REQUEST FOR INFORMATION

Project Name: York Region Admin., Package D Renovation

CONSULTANTS RFI NO: TC24-114-43-X

To: Stephanie Kamburis @ G. Bruce Stratton Architects cc: Victor Chau @ York Region cc: Natalie Freitas @ York Region From: Tom Butkovic, Ivan Lulic, Jay Cowie	REFERENCE: Condensate Drains, 4th Floor Spec. Section: Drawing No.(s): Attachments:
--	--

M-307

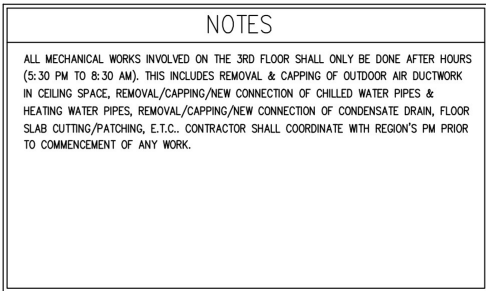
the condensate drains for the 4th floor between stairwells #3 and #2 do not work how they have proposed on the drawing. They show all the new condensate drains connecting into one storm drain. This storm drain does not run as shown on the drawing, and the height of it is our main issue. As it stands right now we can only connect one Fan coil condensate drain into the proposed drain.

One option for us to run is take a couple condensate mains back into the corridor where the condensate drain is being deleted. We would still be deleting further down the line, and we would still cap the take offs where the old condensates were tied in.

Please proceed with the proposed tie-in to existing condensate drain line in the corridor area as per provided sketch.
